**Hertsfield Barn, Marden, Kent, TN12 9BW**

STATEMENT OF

**Dr Paul Ellis, BSc, PhD, CGeol**

**Report reference: 70276R3vn2**

**Figure 2, Surface water drainage scheme**  
 (after 2675/MBCR2/A7, Vol2 part F of the ES, section 4.1 of Hafren 2019, pdf page 325 of the ES).

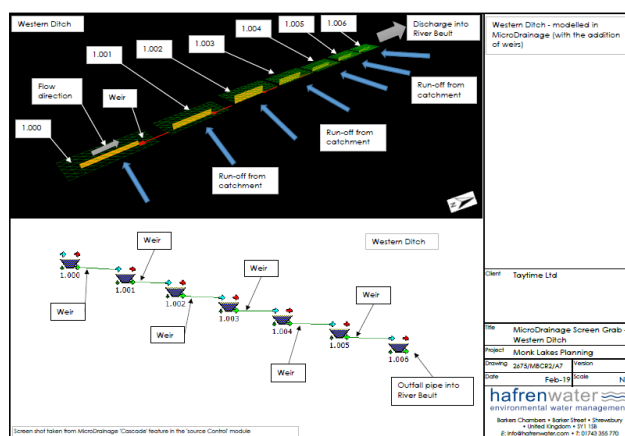
2.1.1 Section 1.11 indicates an Updated Proposed Landscaping Plan (ref. P20-0831\_02) has been submitted and states *'The proposed landscaping along the western and southern appeal site boundary remains the same'*. The proposed surface water attenuation strategy presented as part of the Environmental Statement (Next Phase, February 2019) has not been included within the design which suggests the Appellant has not considered how it will be incorporated within the landscaping of the development, given the limited space along the western margin and the need to avoid locating attenuation basins within the flood plain. The only drawing that we are aware of is the generic screen grab from the run-off model presented below.

- 5.1.8 Updated plans for the planning appeal (ref. P20-0831\_02) do not include the new details of the surface water attenuation scheme comprising attenuation basins and a weir system (see Figure 2675/MBCR2/A7, Vol2 part F of the ES, section 4.1 of Hafren 2019 and Geosmart, April 2019). This suggests the Appellant has not considered how it will be incorporated within the landscaping of the development, given the limited space along the western margin and the need to avoid locating flood attenuation basins within the flood plain.

Figure 1 Estimated groundwater contours (from ESI,2015, Figure 8)

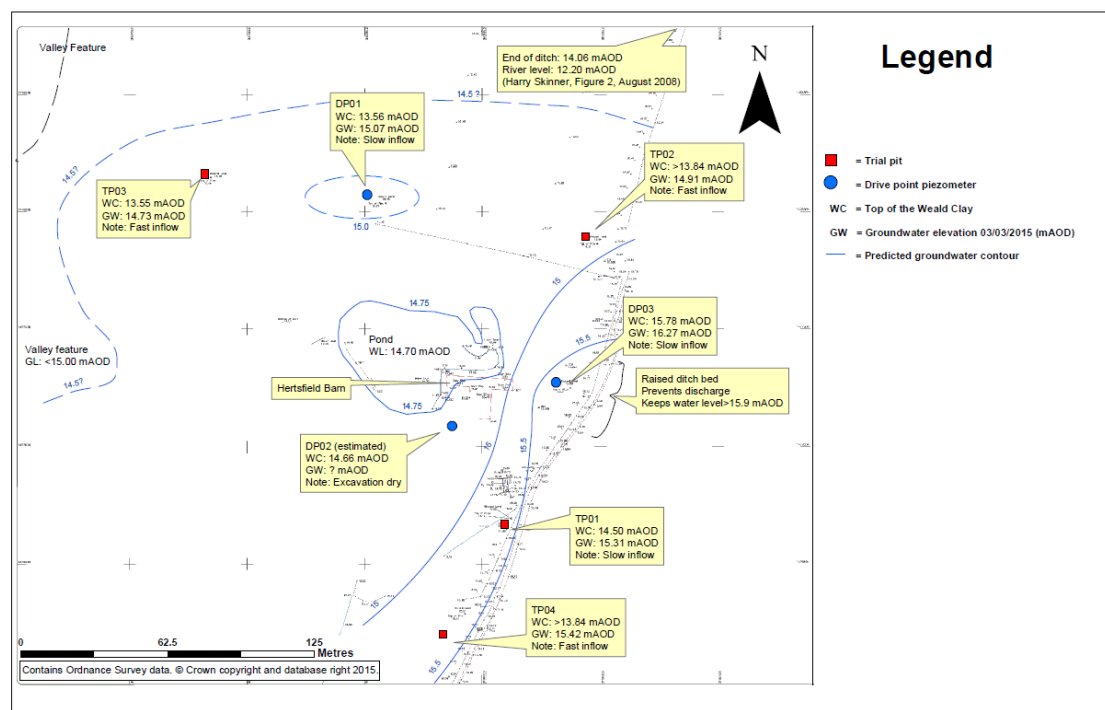
Groundwater contours should include the groundwater low around Hertsfield pond and make reference to the earlier trial pit and groundwater data presented in ESI 2015. As Taytime have not collected any data outside the Western Boundary then the information provided within the ESI report should be considered. If this information is disregarded, then the applicant should state the reasons for this and provide an alternative explanation for the high groundwater and flooding observed.

The groundwater level labelled on the revised contour plot for BH04 is incorrectly labelled as 15.66mAO when in fact it should be 15.26mAO, the level recorded on

Figure 4 LiDAR data showing elevation in mm. Left 2002, Right 2008.

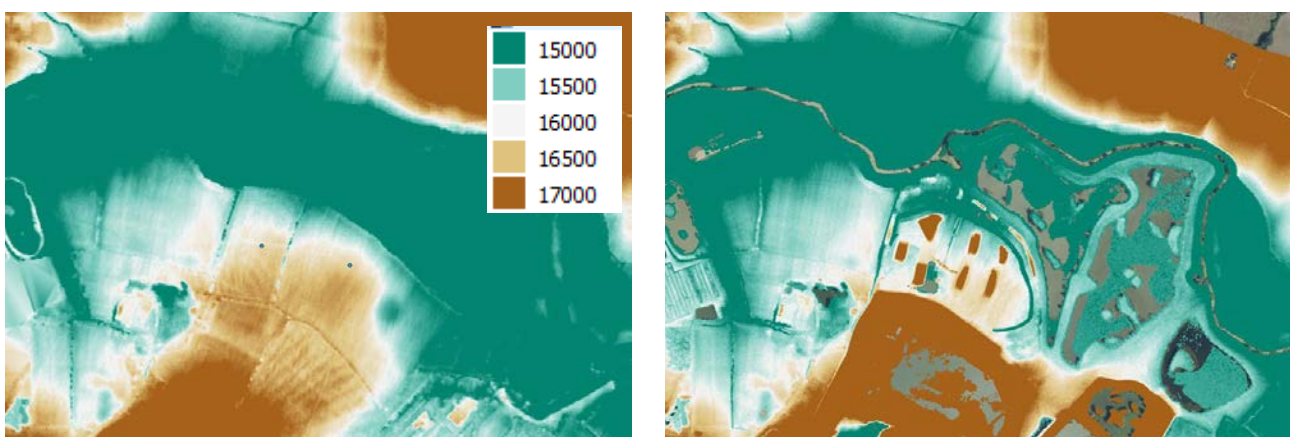
The flood level used in the storage calculation is 16.3 mAOD, which is understood to be derived from flood modelling undertaken by the Environment Agency (EA), labelled '2011 flood line' in the 2012 FRA. It is not known whether the EA model was developed using the 2002 or 2008 LIDAR. If the 2008 data was used for the flood modelling then it would not be appropriate to compare the 16.3 mAOD model output with the 2002 LIDAR levels, as the flood levels would be lower, because the underlying ground levels from which the flood levels were derived would also be lower.

Figure 1 Estimated groundwater contours (from ESI,2015, Figure 8)

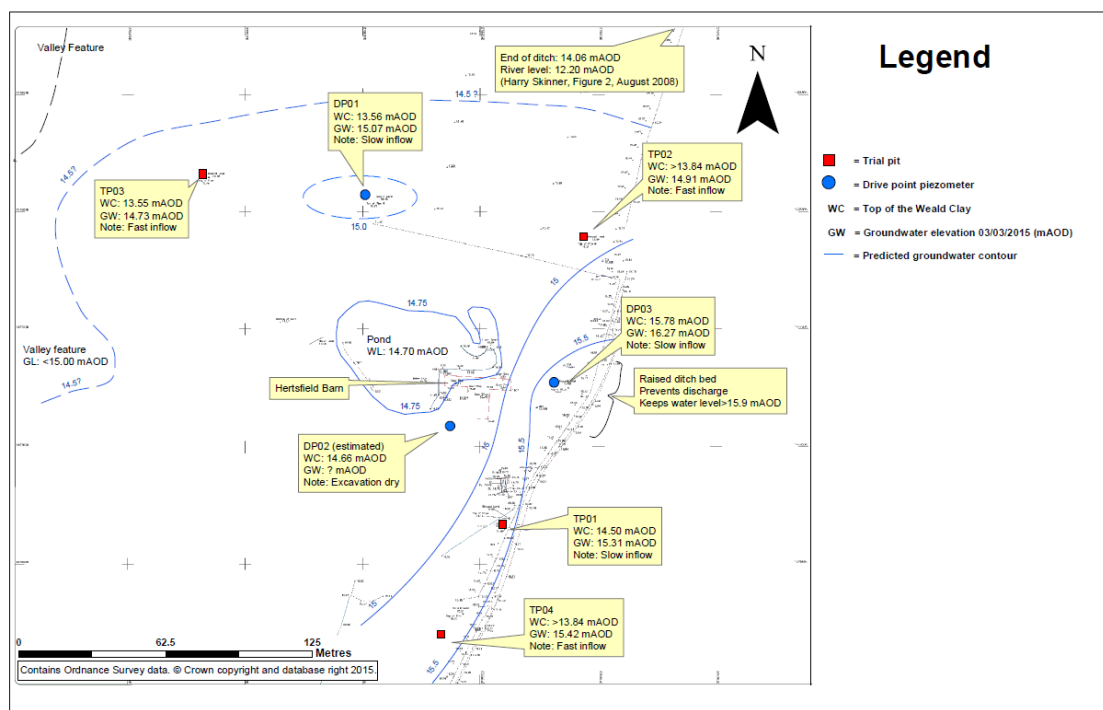
Groundwater contours should include the groundwater low around Hertsfield pond and make reference to the earlier trial pit and groundwater data presented in ESI 2015. As Taytime have not collected any data outside the Western Boundary then the information provided within the ESI report should be considered. If this information is disregarded, then the applicant should state the reasons for this and provide an alternative explanation for the high groundwater and flooding observed.
